Reference: Hanford Waste Vitrification Plant
DOE Contract DE-AC06-86RL10838
Fluor Contract 8457

Transmittal No.: WDOE-912

NUMBER	REV	DATE	TITLE
DCN - #0153	3	04/13/94	DCN TITLE: **Hold on A/G Pwr & Gndg for PX-500-001 A/B and add Firewater Pump Alarm System** "APPROVED FOR CONSTRUCTION"

DCN – 0153	REV 3 (REV. 3 CHANGE)	PAGE 1 OF 46
DCN TITLE: Hold on A/G Pwr & Gndg for PX-500-001A/B and add Firewater Pump Alarm System		DATE INITIATED: 12-20-93
		PACKAGE NO.: A160

ELEMENTARY DIAGRAM 21
FOR PX-500-002A REMOTE OUTPUTS 122083

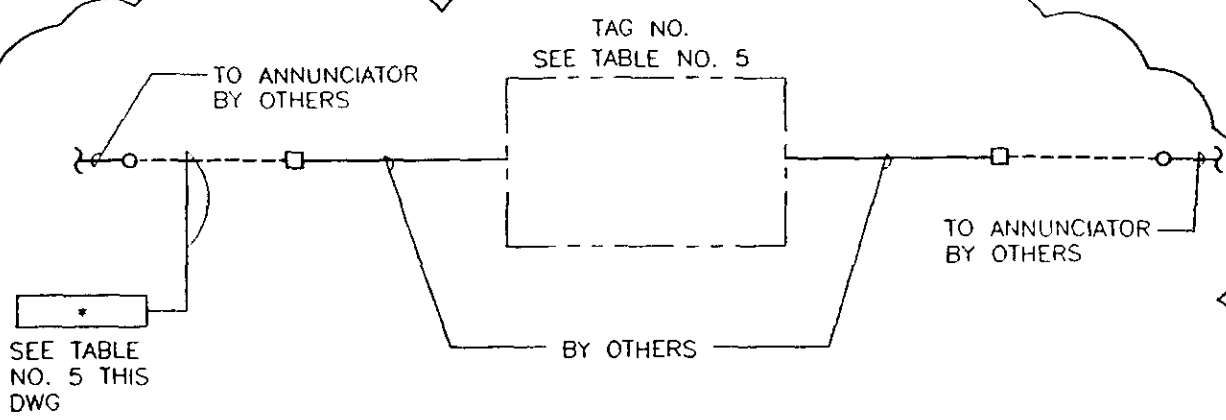
TABLE NO. 5		
TAG NO.	DESCRIPTION	CABLE NO. * (2/C)
XL-FWX-***B	PUMP PX-500-002A RUNNING	A0912
	PUMP PX-500-002A CONTROLLER PWR AVAILABLE	A0913
	PUMP PX-500-002A PHASE REVERSAL	A0914
ZAL-FWX-017-1B	PUMP PX-500-002A DISCHARGE VALVE NOT FULLY OPEN	A0915
ZAL-FWX-012-1B	PUMP PX-500-002A SUCTION VALVE NOT FULLY OPEN	A0916
PAL-FWX-005B	LOW FIRE WATER HEADER PRESSURE	A0917

ELEMENTARY DIAGRAM 25
FOR PX-500-002B REMOTE OUTPUTS 122083

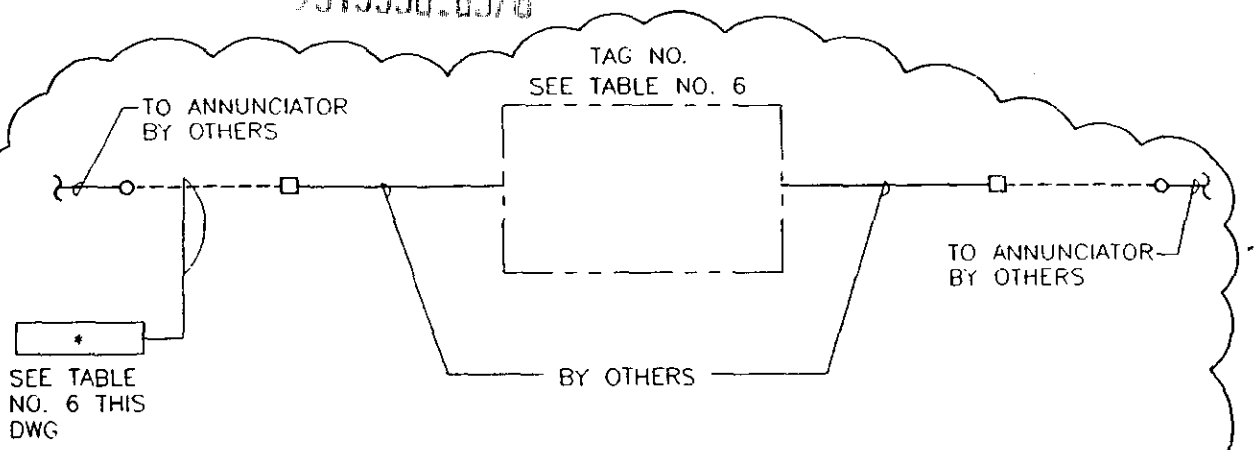
TABLE NO. 6		
TAG NO.	DESCRIPTION	CABLE NO. * (2/C)
XL-FWX-***B	PUMP PX-500-002B RUNNING	A0918
	PUMP PX-500-002B CONTROLLER PWR AVAILABLE	A0919
	PUMP PX-500-002B PHASE REVERSAL	A0920
ZAL-FWX-017-2B	PUMP PX-500-002B DISCHARGE VALVE NOT FULLY OPEN	A0921
ZAL-FWX-012-2B	PUMP PX-500-002B SUCTION VALVE NOT FULLY OPEN	A0922
TALL-FWX-005B	FIRE & PROCESS WATER STORAGE TANK LEVEL	A0923

□ TERMINAL @ FIRE WATER PUMP PANEL LP-500-002B (TALL-FWX-0005B TERMINAL @ LP-500-007)

TB-20-A2
(FIRE WATER PUMP HOUSE)

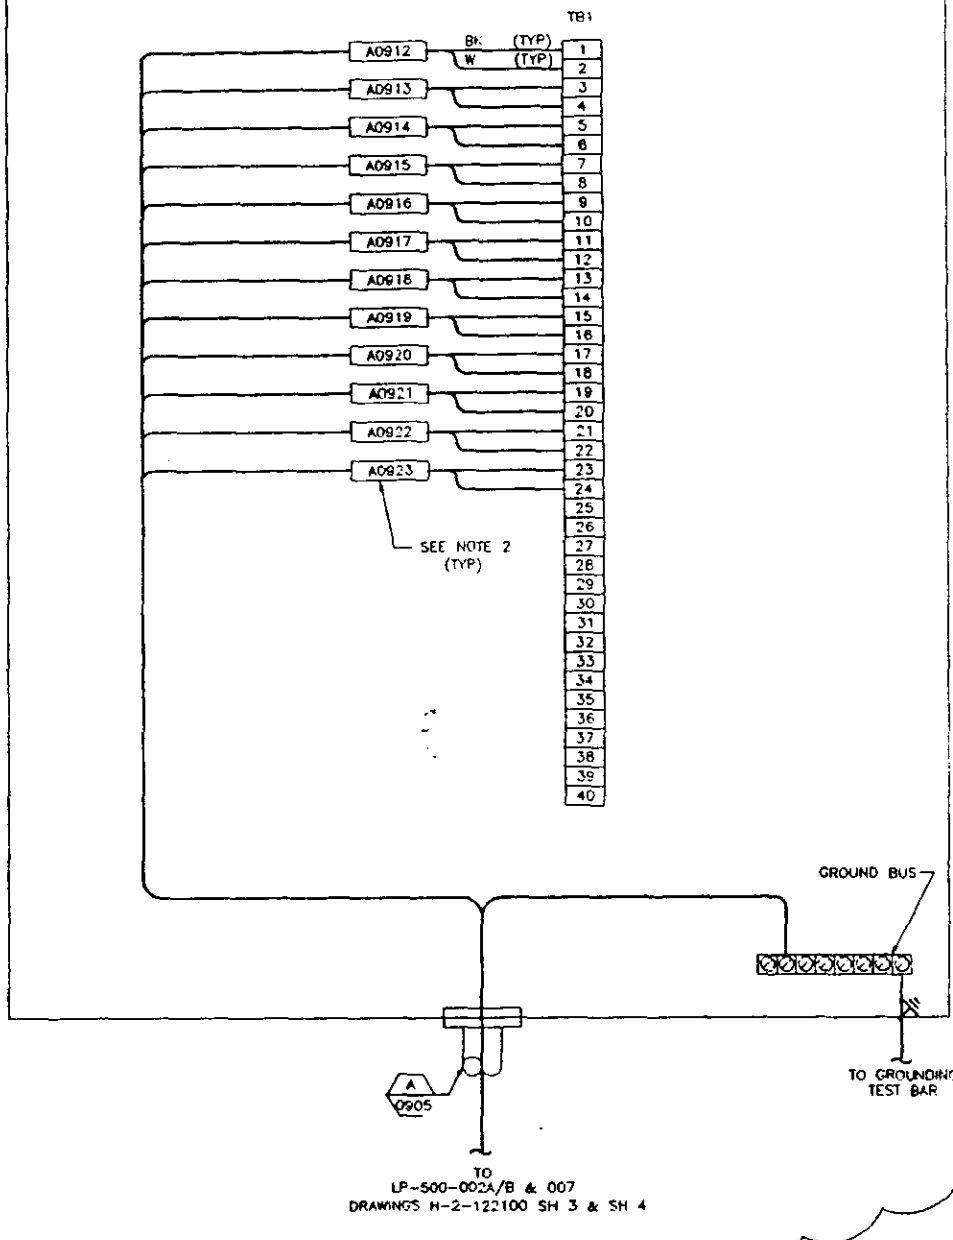
DESCRIPTION OF CHANGE:
HOLD ON A/G PWR & GNDG FOR PX-500-001A/B & ADD FIREWATER PUMP ALARM SYSTEM

BASE DOC. NO. H-2-122099 SHT/PG. 2 REV. 1 REV. 2 CHANGE
CR NO. 1069 R1 & 1006
DISCIPLINE: ELECTRICAL

BASE DOC. NO. H-2-122100
SHT/PG. 1 REV. 1
CR NO. 1069 R1 & 1006
DISCIPLINE: ELECTRICAL

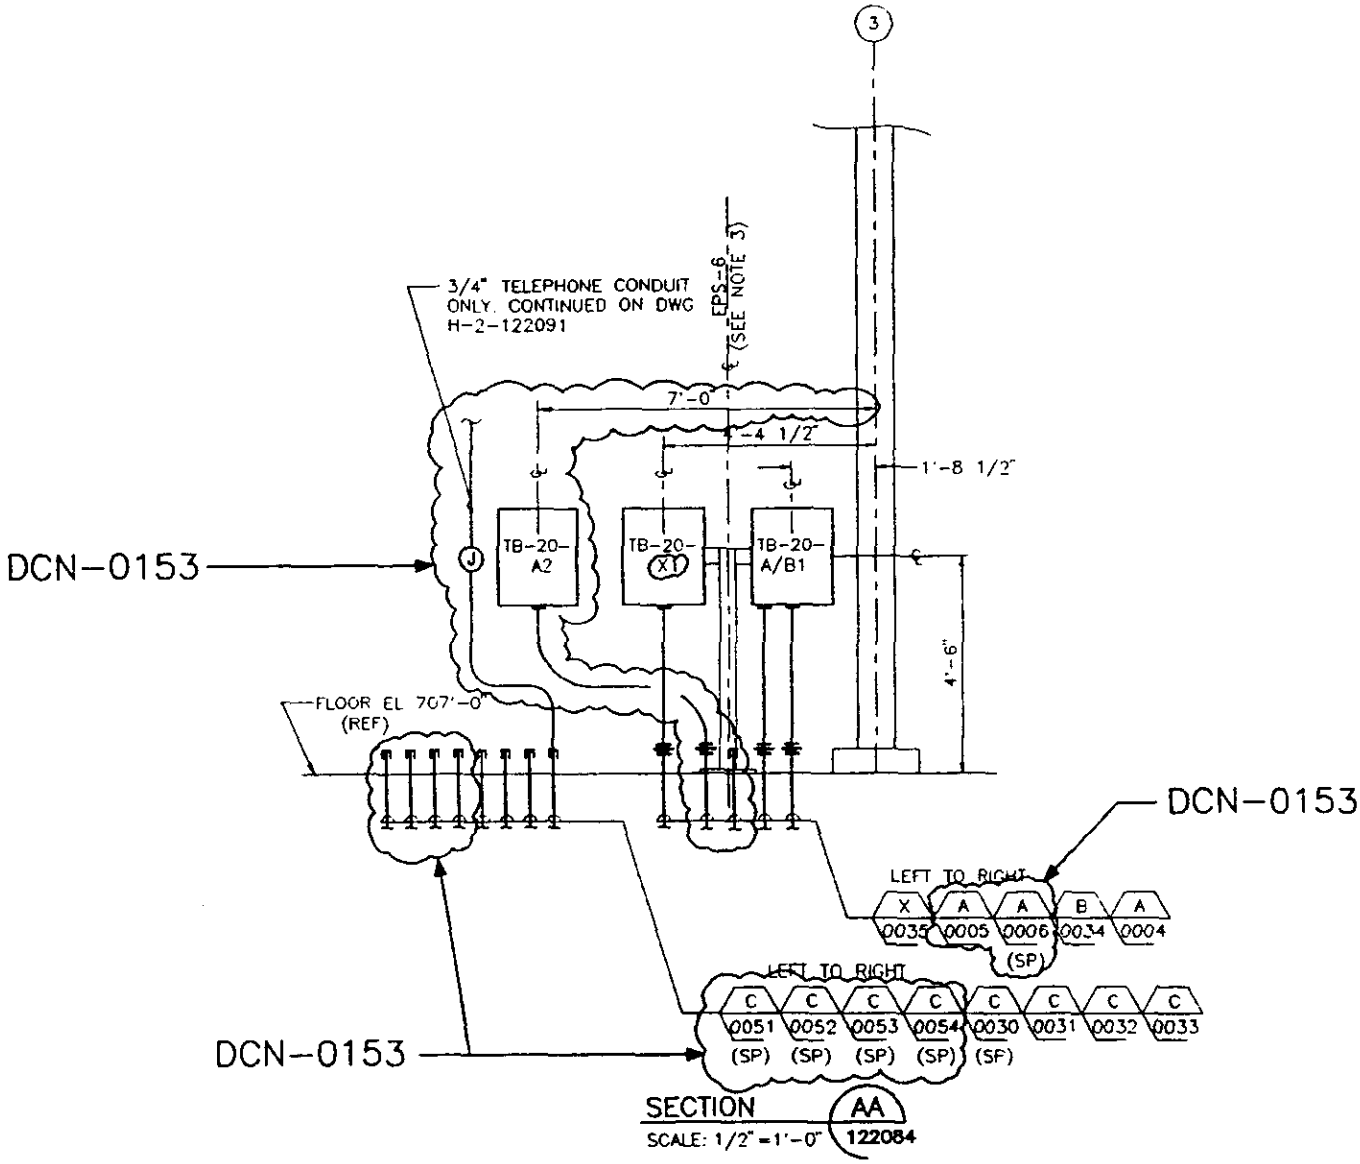
H-2-122100	1	1	ELECTRICAL CONNECTION DIAGRAMS	Y	ADDED TERMINAL BOX WIRING DIAGRAM (REV. 2 CHANGE)
H-2-122100	2	1	Electrical Connection Diagrams	Y	Placed Hold No. 450
H-2-122100	3	0	Electrical Connection Diagrams	Y	Added instrument cable
H-2-122100	4	0	Electrical Connection Diagrams	Y	Added instrument cable
H-2-122100	7	0	Electrical Connection Diagrams	Y	Placed Hold No. 450 (REV. 1 CHANGE)
Specification B-595-C-A160-16111 Attachment A	1, 6, 7, 9, 10, 11, 17	2	Conduit Schedule	Y	Added conduit for instruments and placed Hold No. 450 (REV. 1 CHANGE) Revised designations on P. 17

LP-500-002A
(FIRE WATER PUMP HOUSE)

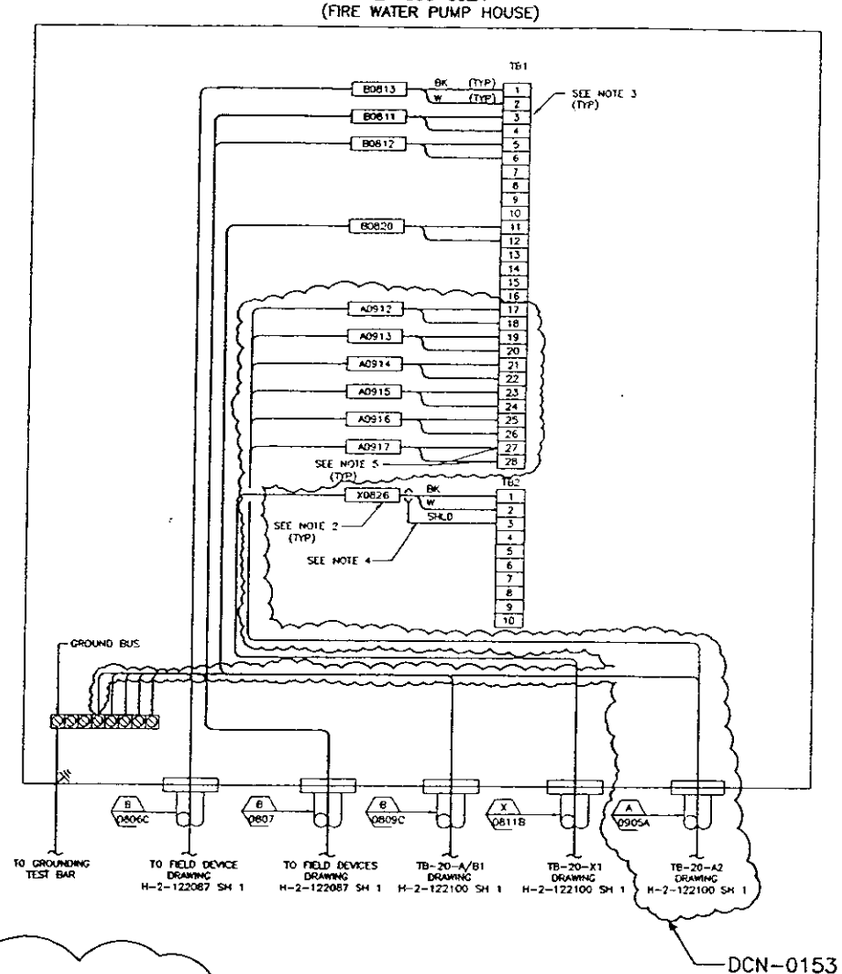
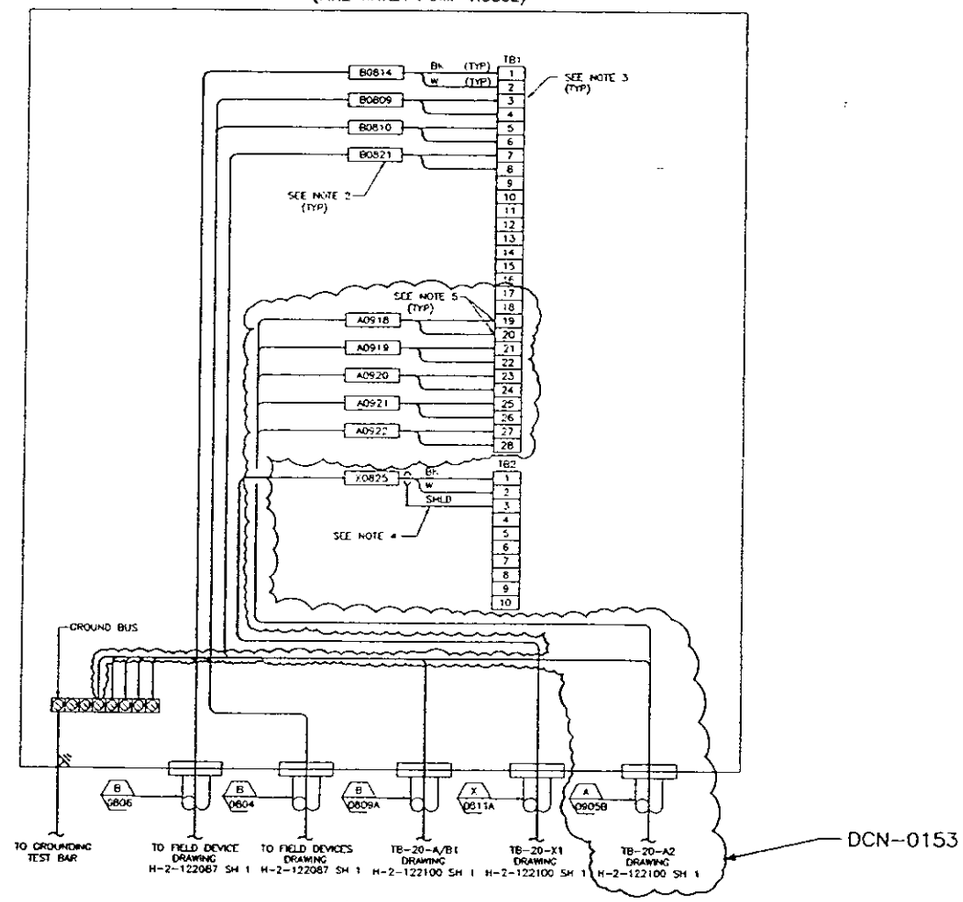
5. FINAL TERMINATION POINTS FOR CONDUCTORS SHALL BE DETERMINED UPON RECEIPT OF FINAL VENDOR INFORMATION.

FLUOR DANIEL	U.S. DEPARTMENT OF ENERGY HANFORD WASTE VITRIFICATION PLANT	DESIGN CHANGE NOTICE
DESCRIPTION OF CHANGE: HOLD ON A/G PWR & GNDG FOR PX-500-001A/B & ADD FIREWATER PUMP ALARM SYSTEM		BASE DOC. NO. H-2-122100 SHT/PG. 4 REV. 0 CR NO. 1069 R1 & 1006 DISCIPLINE: ELECTRICAL
PREPARED BY: R. Spurgi DATE: 12/23/93 DISCIPLINE ENGINEER: K. L. Dissanayake DATE: 2/17/94		DCN-0153 REV. 3 PAGE 29

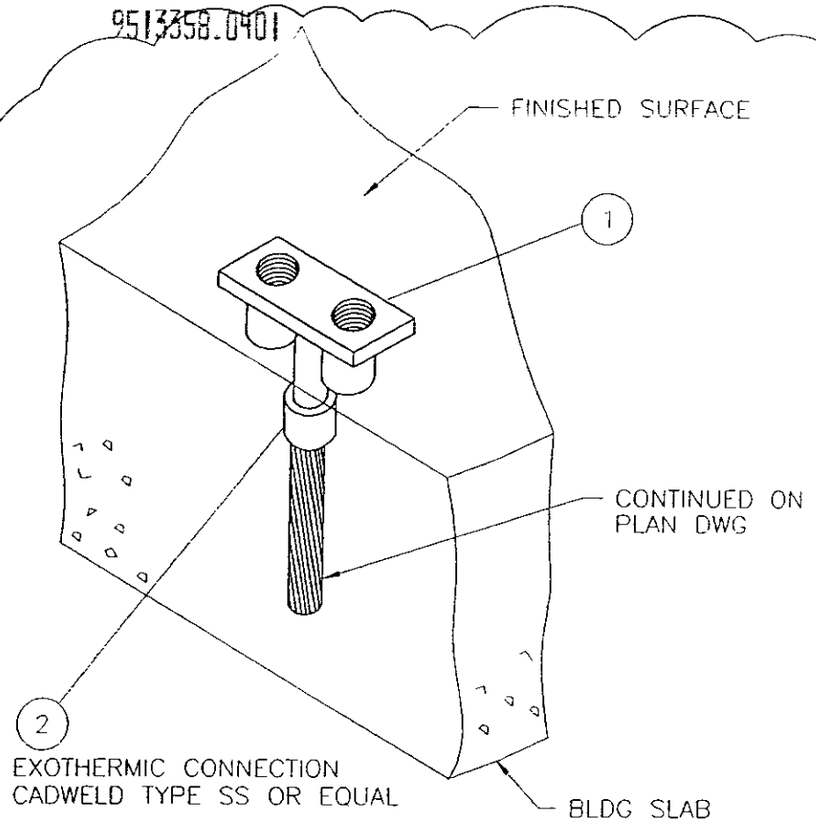
NOTE:
THE INFORMATION CONTAINED ON THIS PAGE TO BE INCLUDED ON SHEET 6 OF DRAWING H-2-122082 WHICH WILL BE ADDED AT THE NEXT REVISION.

• NAMEPLATE LEGEND TABLE

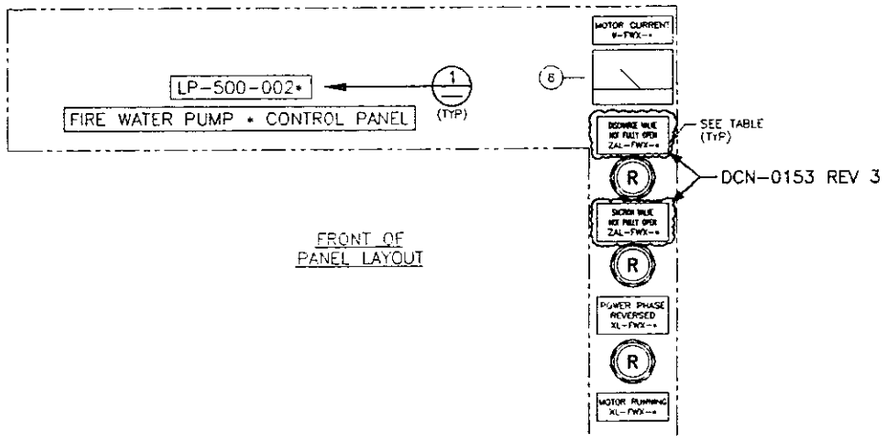
B-595-C-A160-15540	11	1	Firewater System Pumps	Y	Revised Para. 2.2.10.B
B-595-C-A160-15540	12	1	Firewater System Pumps	Y	Revised Para 2.2.10.B
H-2-121656	1	0	LP-500-002A & 002B Instrument Panel Layout	Y	Revised Nameplate Inscriptions
